2D-F7

THE PENNSYLVANIA RAILROAD
FREIGHT CARS
TRUCK
A.R.A. No. 1
ALTOONA, JUNE 15
CIRCUIT OF ACTIVE POWER
80765

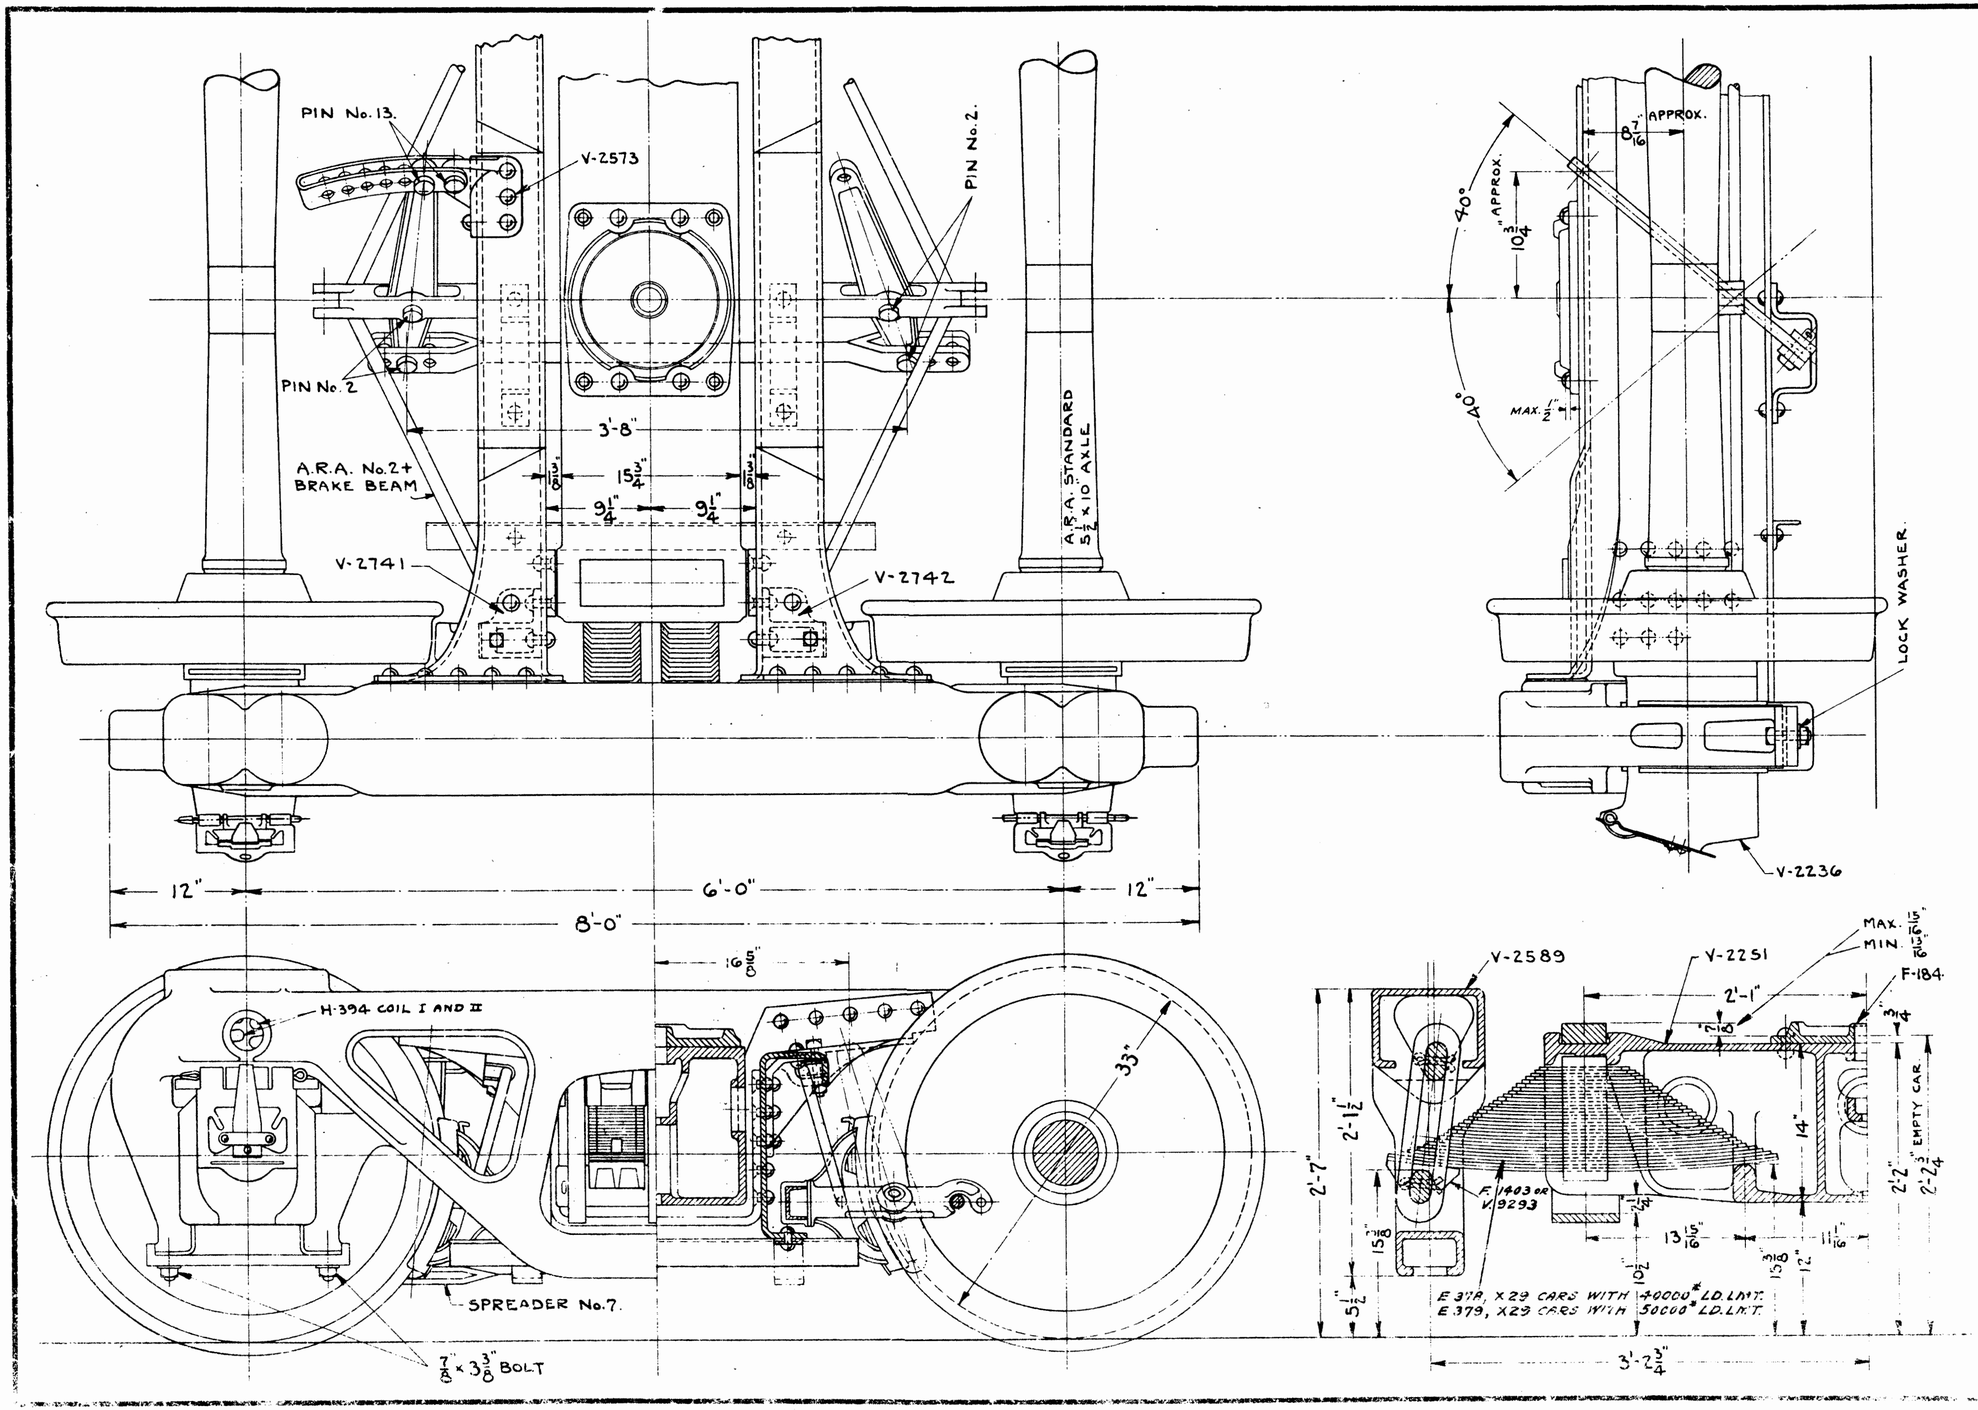
ELLIPTICAL SPRINGS CHANGED FROM E 360 TO E 378 OR E 379. 8-26-1927

THE FOUR OUTER RIVETS IN CENTER PLATE HAVE BEEN FLATTENED TO A HEIGHT NOT EXCEEDING 1/2" 8-17-1933 (F-46-37)

SUSPENSION SPRING HAS BEEN REMOVED AND SAFETY SUPPORTS FOR BRAKE BEAM AND SPREADER SHOWN. 7-20-1942 (F-51-42)
